Re: Tract N-1-B Watershed Subdivison - Sketch Plat Submittal

TRACTS N-1-B, WATERSHED SUBDIVISION zoned **PC**, located on **ARROYO VISTA** between **118TH ST** and **98TH ST** containing approximately 60.08 acre(s). (J-8)

Project No: PR-2024-010571 **Date:** 7/3/2024 **Agenda Item:** #12 **Zone Atlas Page:** J-8

Project Name: Subdivide Tract N-1-B

PLAT OF
TRACTS N-1-A & N-1-B
WATERSHED SUBDIVISION
(A REPLAT OF TRACT N-1,
WATERSHED SUBDIVISION)
PROJECTED SECTIONS 17 AND 18,
TOWNSHIP 10 NORTH, RANGE 2 EAST,
N.M.P.M.
ALBUQUERQUE,
BERNALILLO COUNTY, NEW MEXICO
AUGUST, 2023

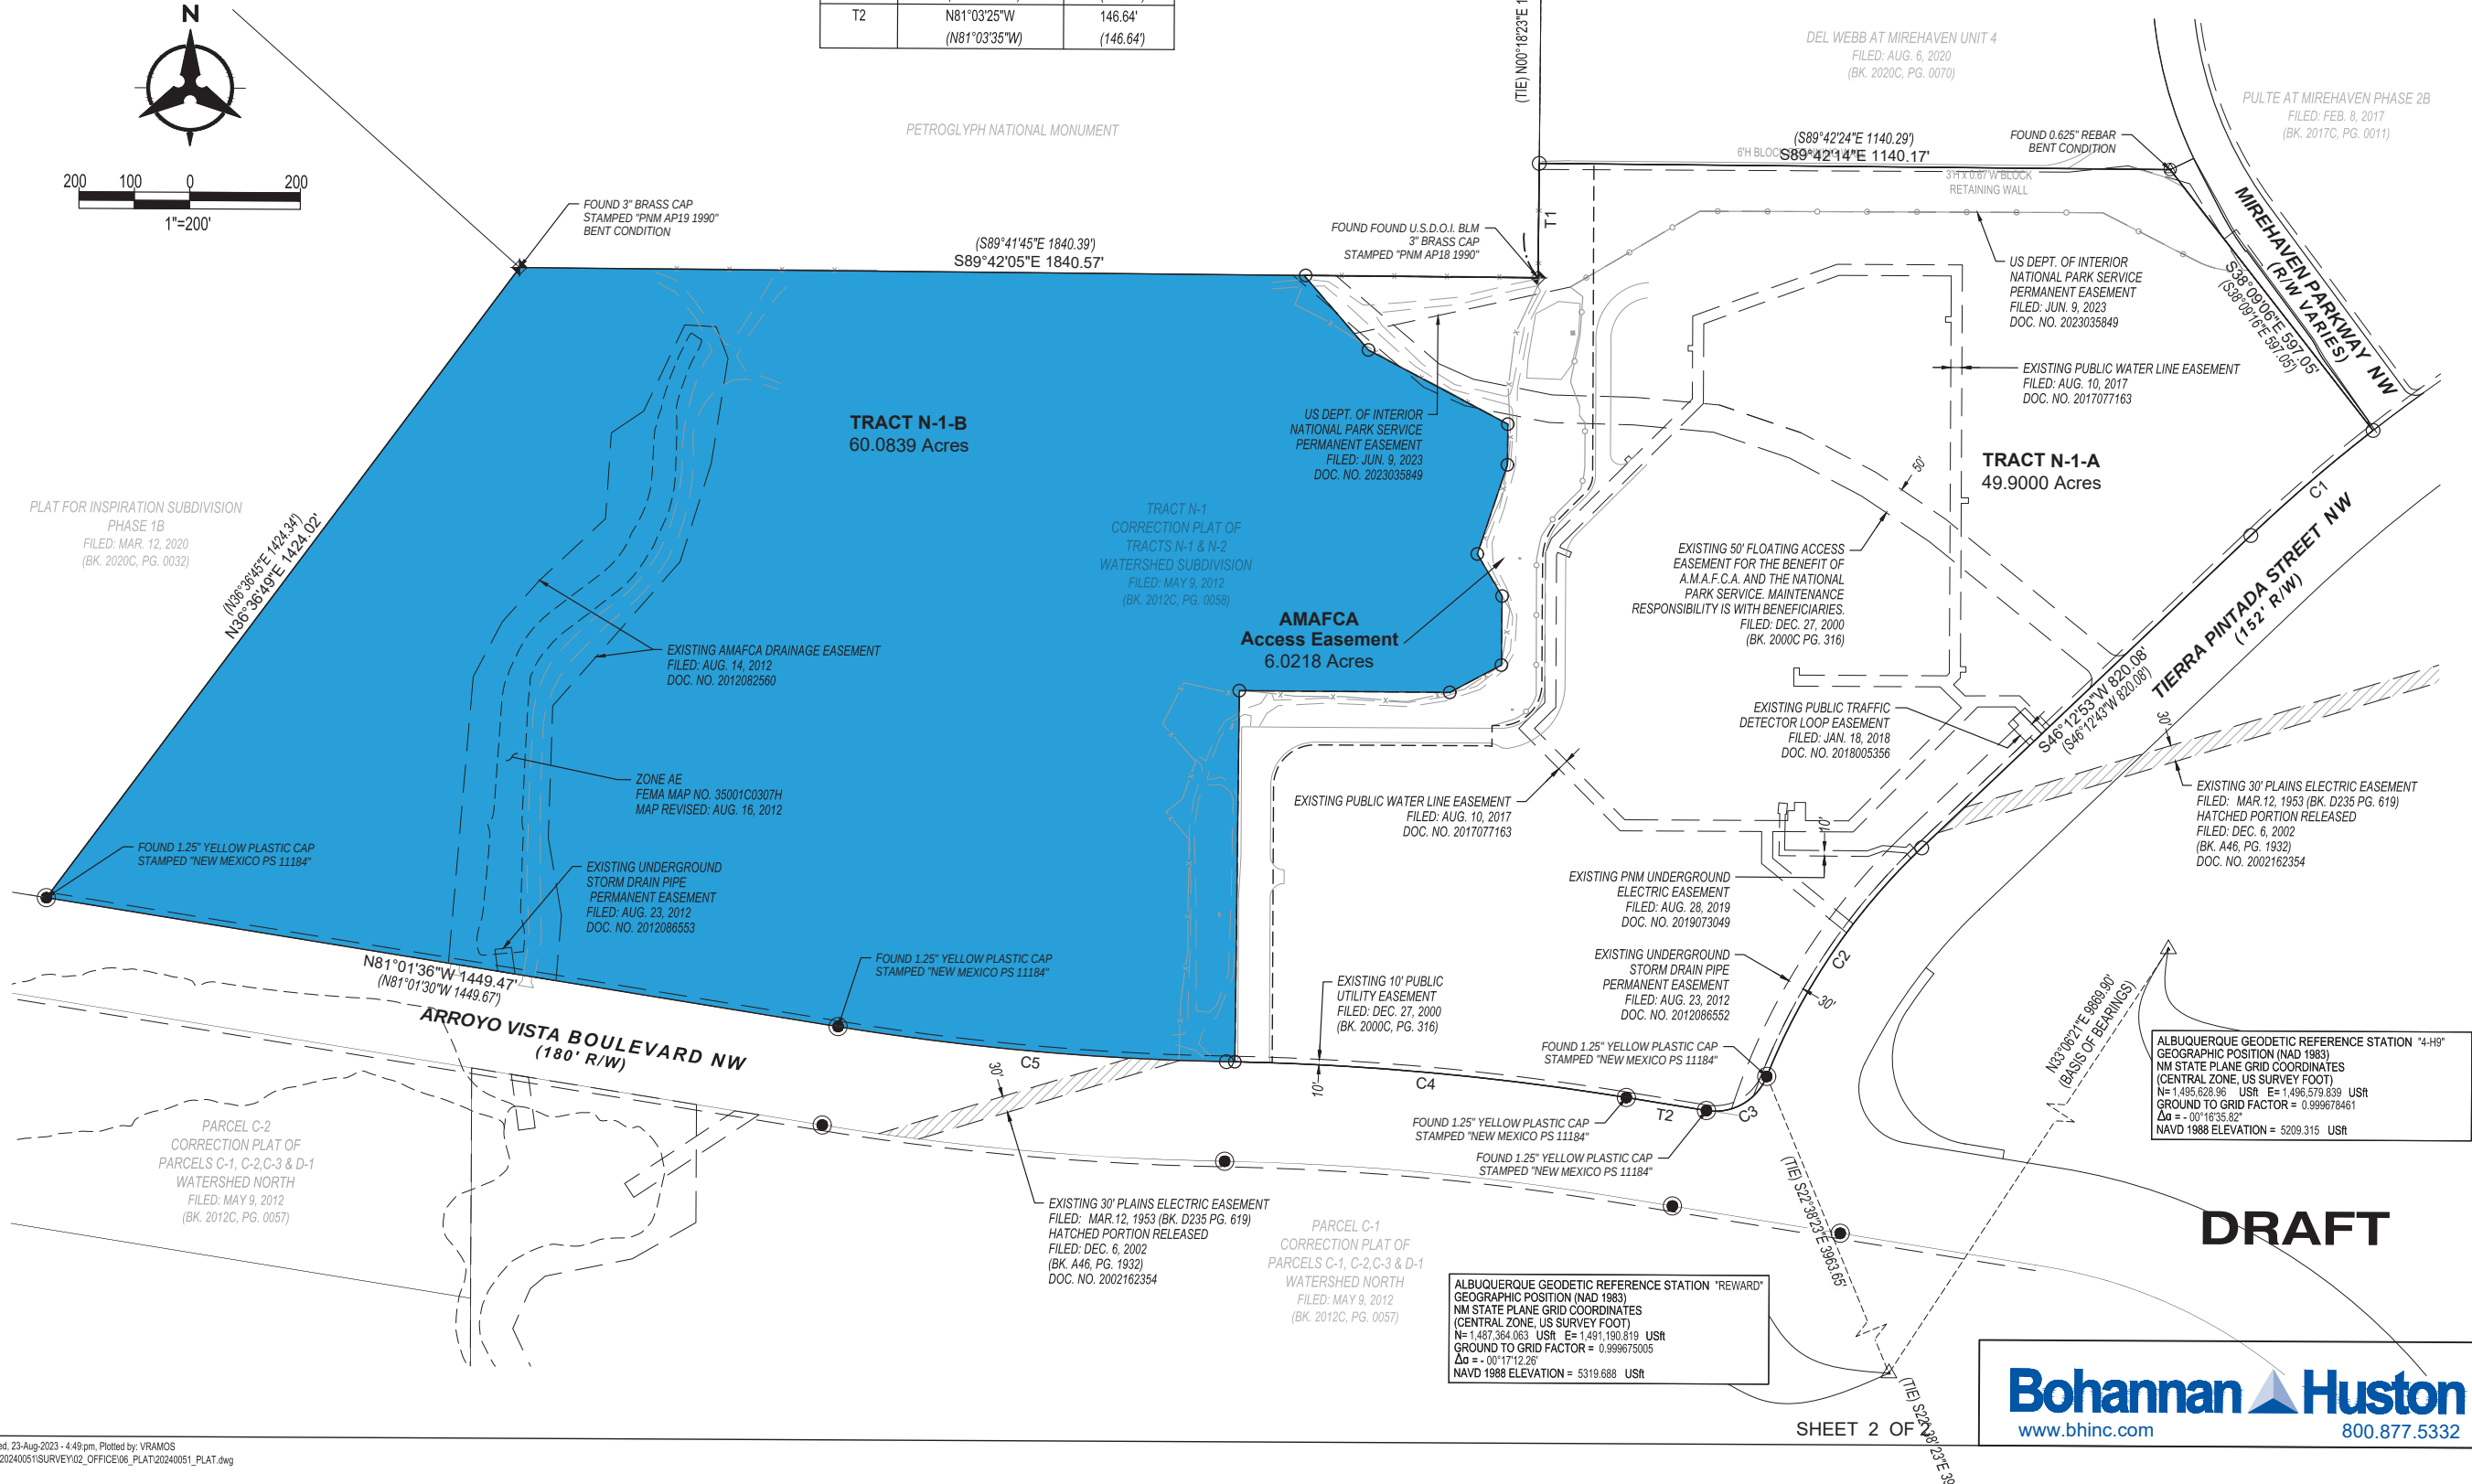
- A previous sketch plat was reviewed April 17, 2024. That Sketch Plat review request was for a Bulk Land Plat, subdividing an existing tract, Tract N-1 of the Watershed subdivision, into Tract N-1-B at 60.0839-acres in size and Tract N-1-A at 49.9-acres in size. **Tract N-1-A and Tract N-1-B still need to be created. Tract N-1-B could then be further subdivided.**

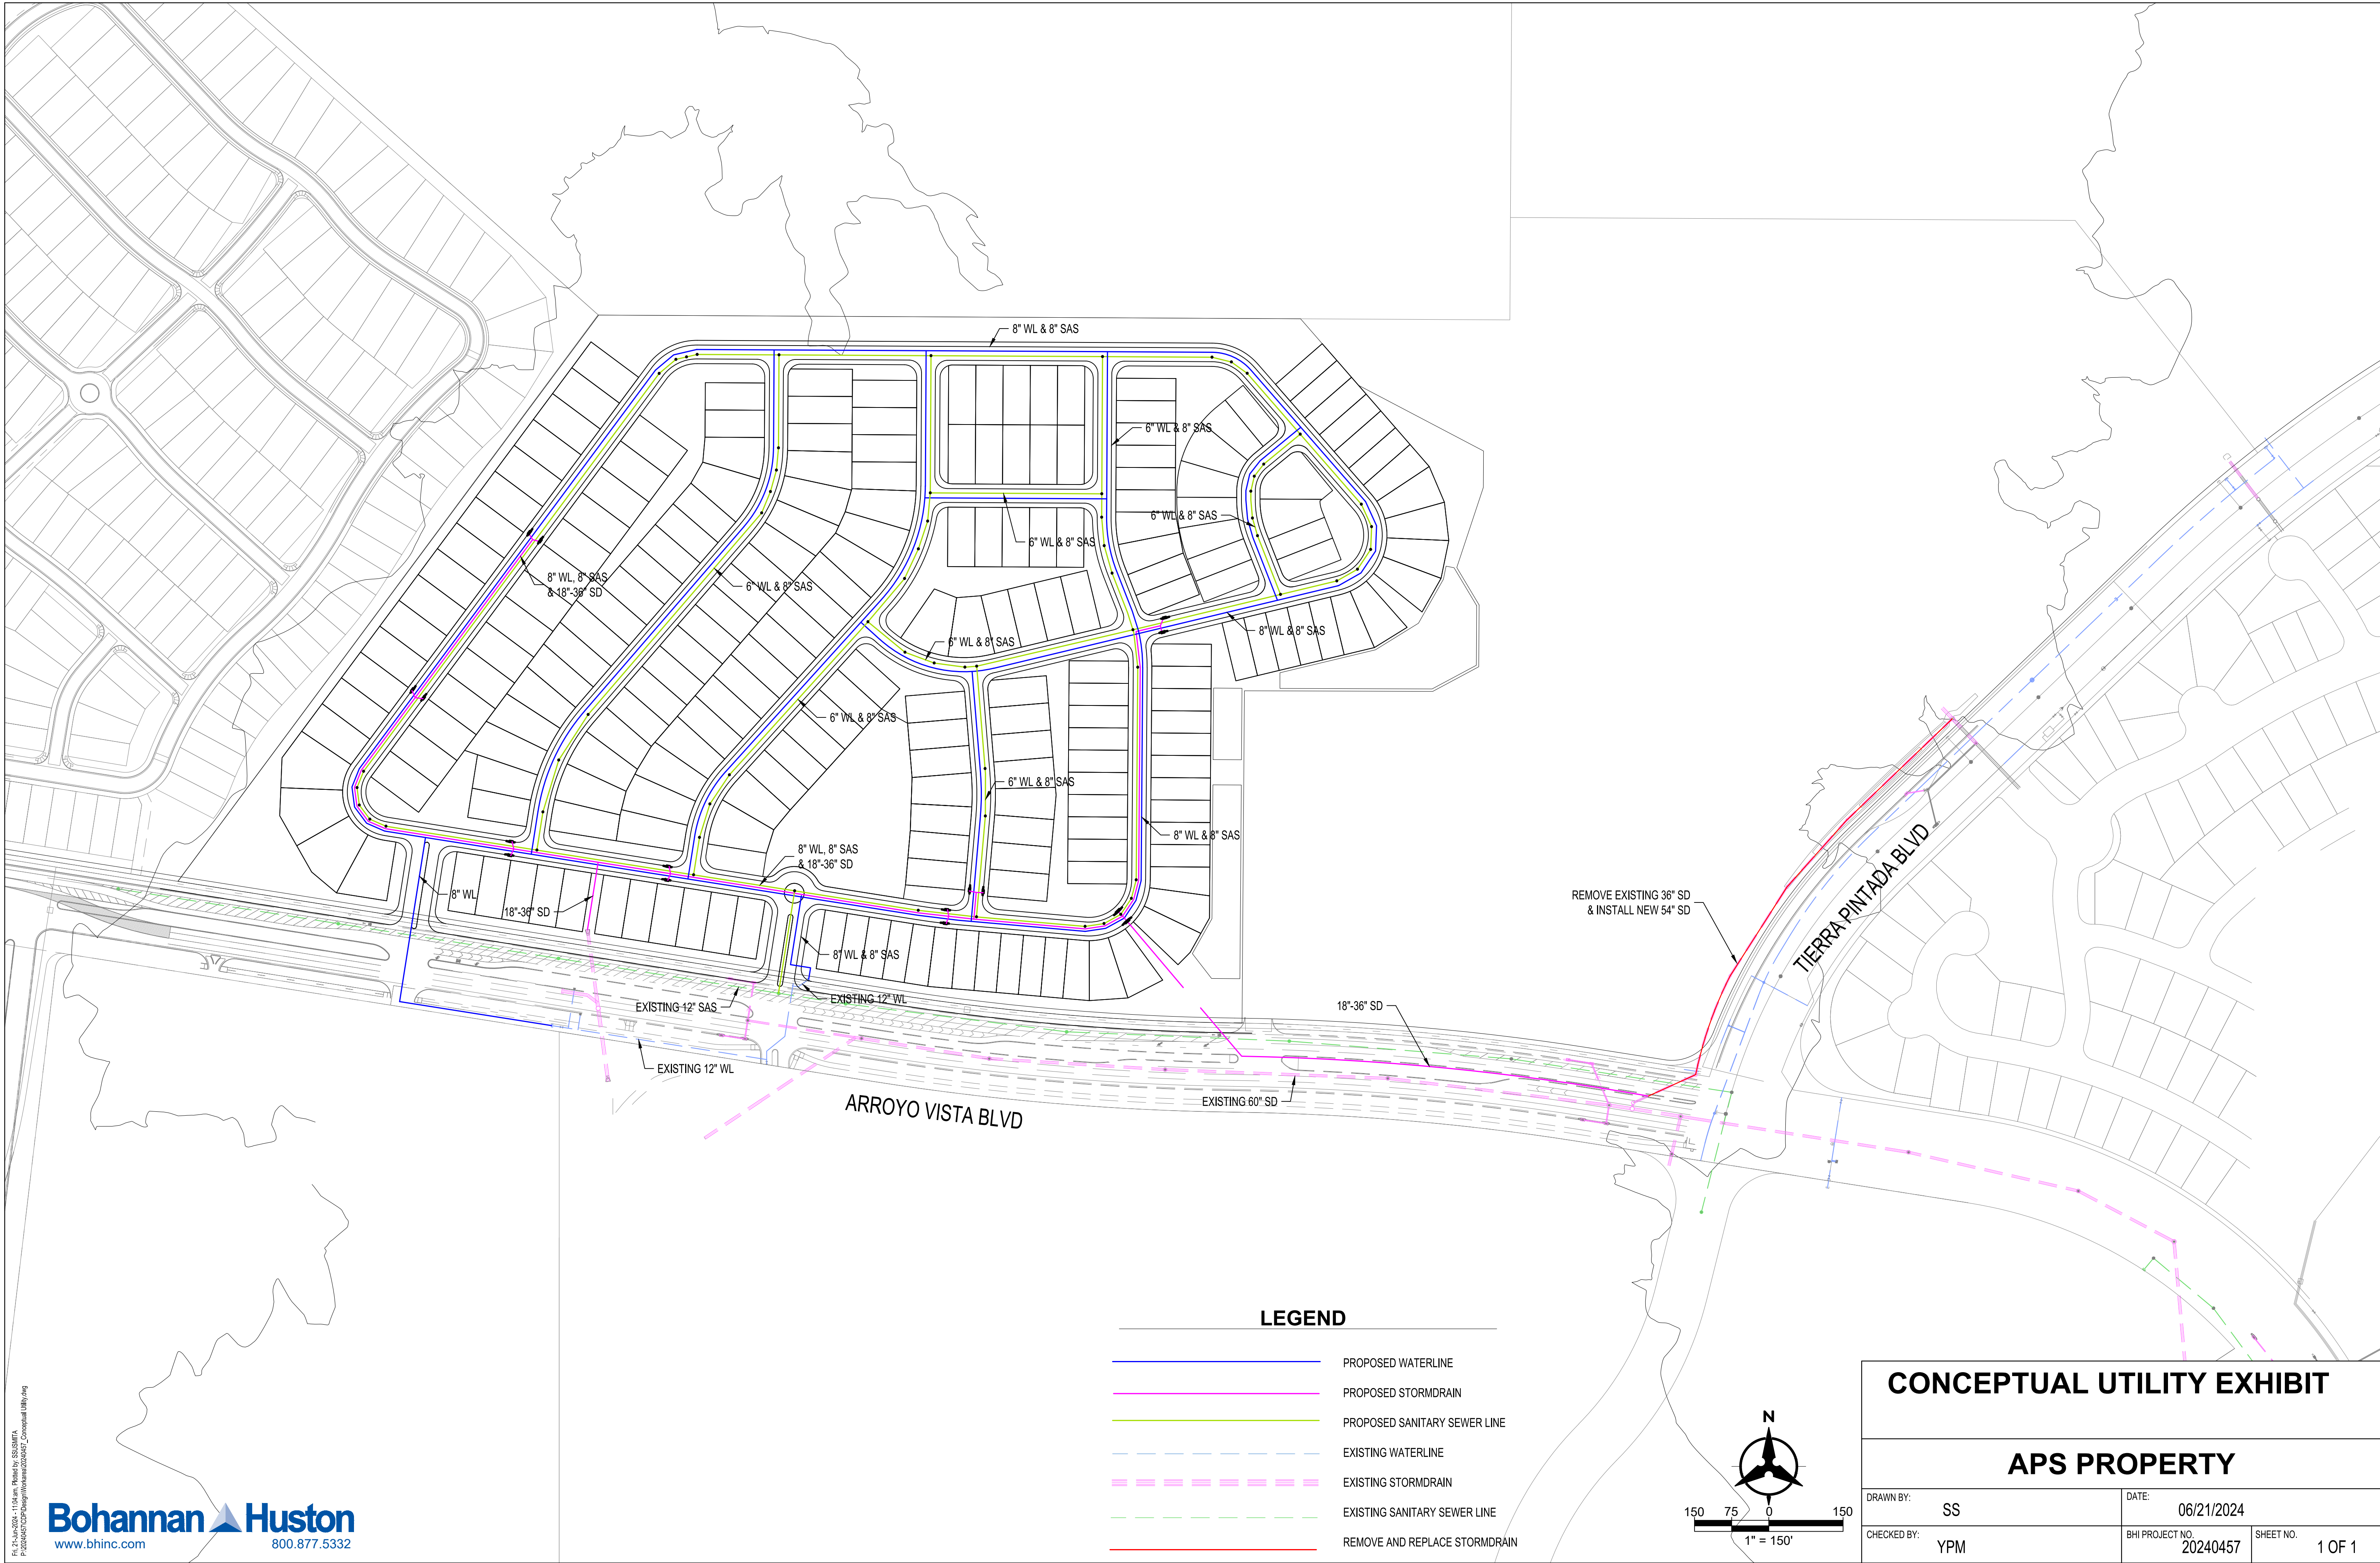
1. Request an availability/serviceability statement online at the following link:
http://www.abcwua.org/Availability_Statements.aspx. Requests shall include fire marshal requirements. An executed statement must be obtained prior to approval.
2. Regarding the comment for water, please provide a maximum pad elevation for the site to determine if there is any need for 5W infrastructure.
 - a. Note that the highest contour I see for the site based on our mapping system is right at the 5W/4W pressure zone boundary at 5485 feet which is evident the entire site currently sits within the 4W pressure zone thus not requiring a PRV to provide pressure to the site.
3. As proposed the site is on a really long dead end line and will require some sort of loop. Perhaps to the adjacent site on APS site which will create a good looped water system to provide redundancy for the future development.

1. Arroyo Vista is a Principal Arterial and requires a 6' sidewalks with a 5' to 6' landscape buffer. There is an existing multiuse trail along here which meets sidewalk requirements.
2. All internal roads would be local roads and require 5' sidewalk with a 4' to 6' landscape buffer.
3. Prior to site plan an approved TCL is required. Also, please submit a Traffic Scoping Form to Curtis Cherne (ccherne@cabq.gov) to determine if a TIS is required.

- Hydrology will need to approve a Conceptual Grading & Drainage Plan prior to platting.
- The infrastructure list will be needed for Preliminary Plat.
- Hydrology will also need AMAFCA's approval prior to plat approval.

This site requires a Site Plan EPC prior to subdivision of land with the DHO.

It is noted that a single-loaded street has been placed on the edge of the subdivision adjacent to Petroglyph National Monument which meets of the requirements of 5-2(J).

It would appear that you have been able to keep some block lengths under 600 feet, but some are not.
